# **Coppersmith Corner Proposed Expansion**

April 15, 2015 DP Panel Presentation

Schedule 2 to the Minutes of the  
Development Permit Panel  
meeting held on Wednesday,  
April 15, 2015.

# Integration Into Existing Centre

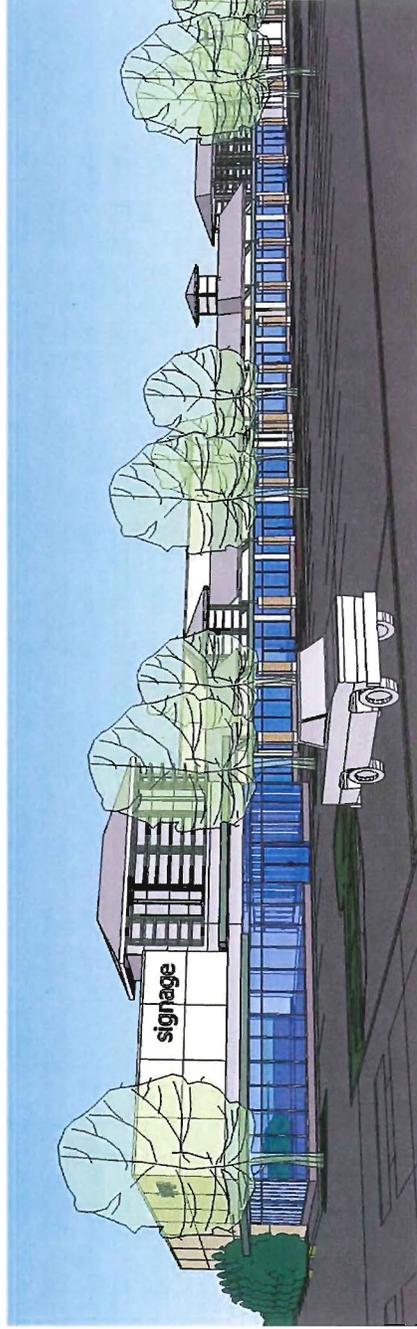
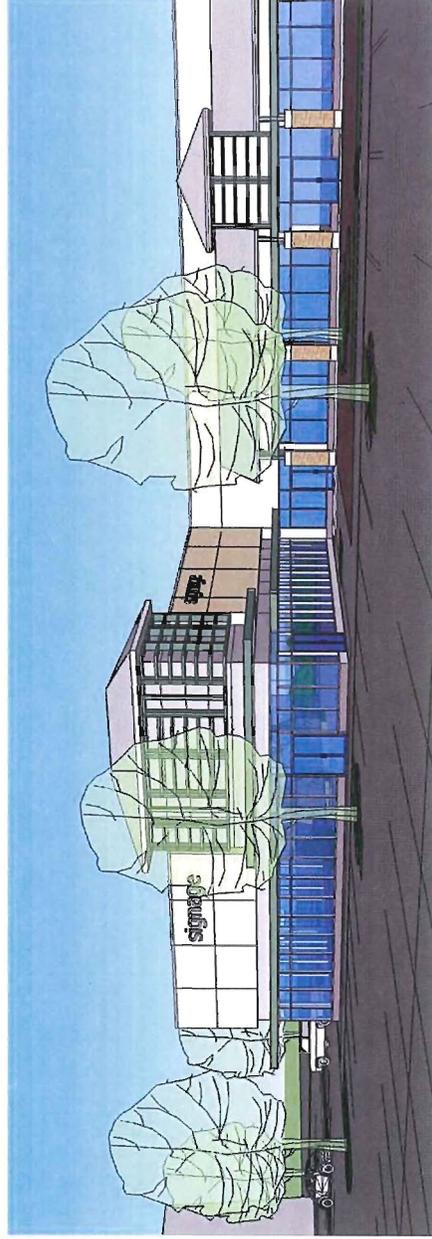
**Enhancements to urban design and architectural form and character that would improve integration with other buildings on the site and accessibility to neighbouring site.**

This comment was addressed in the revised submission through:

- Matching the governing heights, matching window heights and modules, repetition of the steel canopy detail, employing a simpler and more unified materials palette drawn mostly from the existing Centre and incorporating a feature entry to continue the theme of 'feature towers'.

# Mitigating the Impact

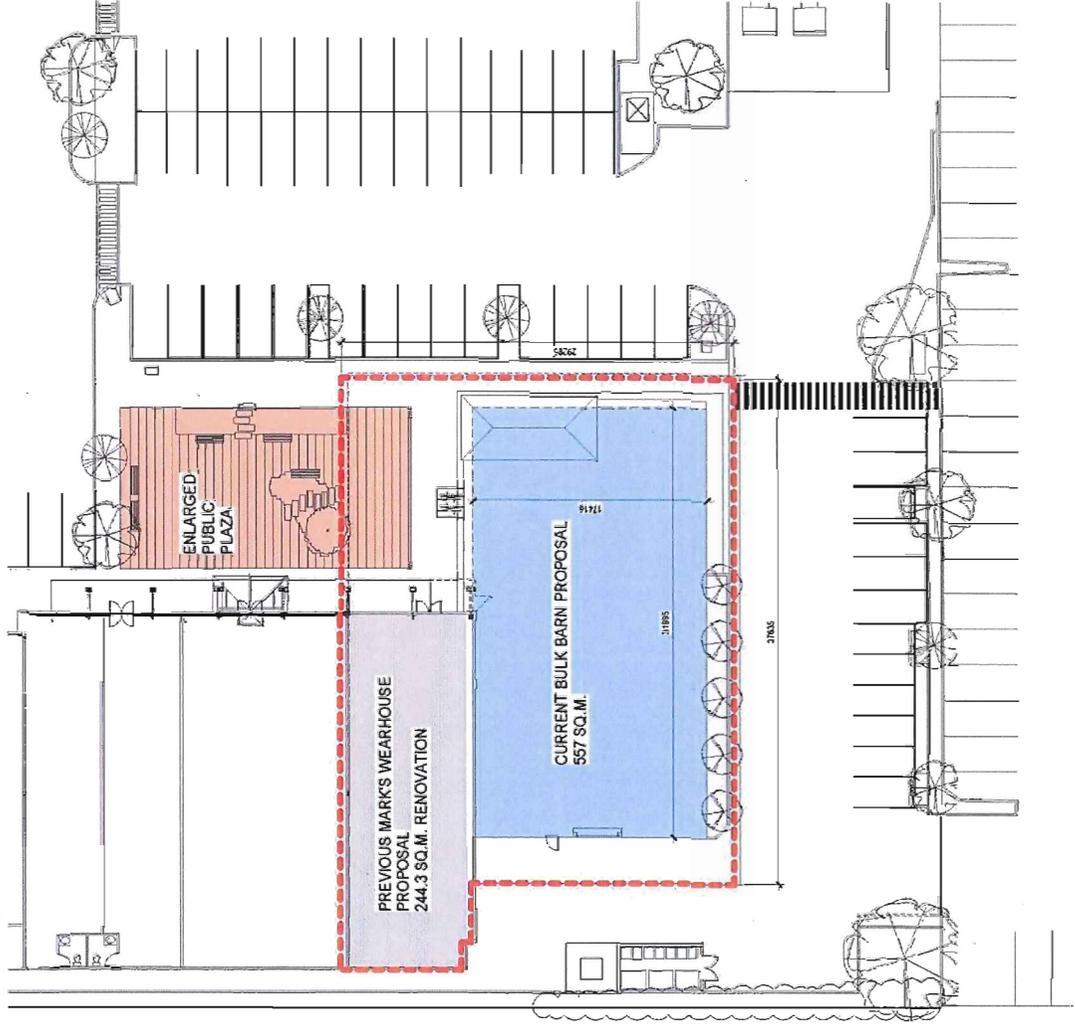
## Comments from July 2014 DP Panel

- Mitigating the impact of the proposed addition on the south neighbour by:
  - reducing the building area by 1/3 (879 sm vs. 557 sm),
  - reducing the north frontage by approx. 8 feet,
  - adding glazing to the south façade, and
  - re-instating the landscaping on the south property line.
  - replacing the sloped canopy with a glazed canopy to improve visibility to the neighbors building
  - encouraging a direct pedestrian connection from our new development to the neighbour's retail units

Previous expansion area: 879 sm

Revised expansion area: 557 sm

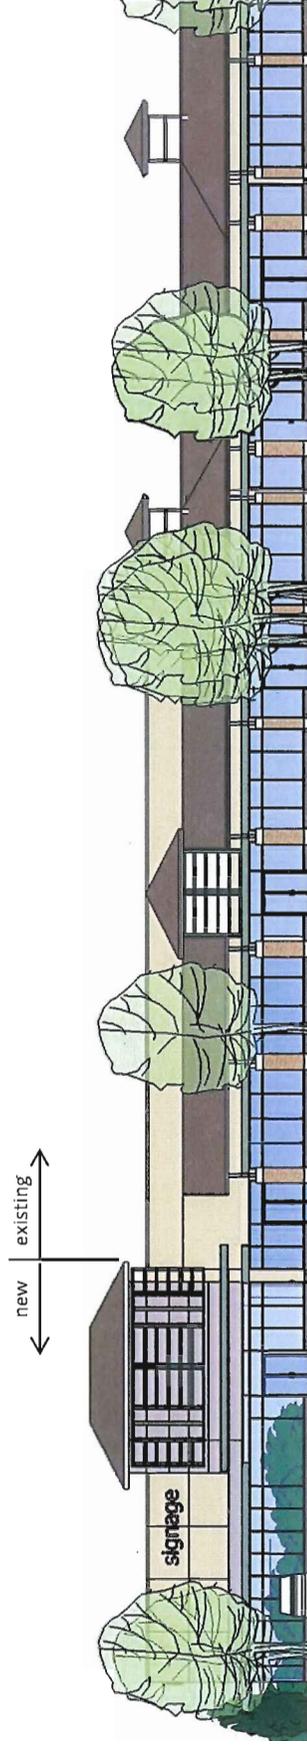
### **Changes to the location and ratio of small vehicle and regular vehicle**

This comment was addressed in the revised submission through:

- Parking layout revised and have distributed the small car stalls throughout the entire Centre's parking area.
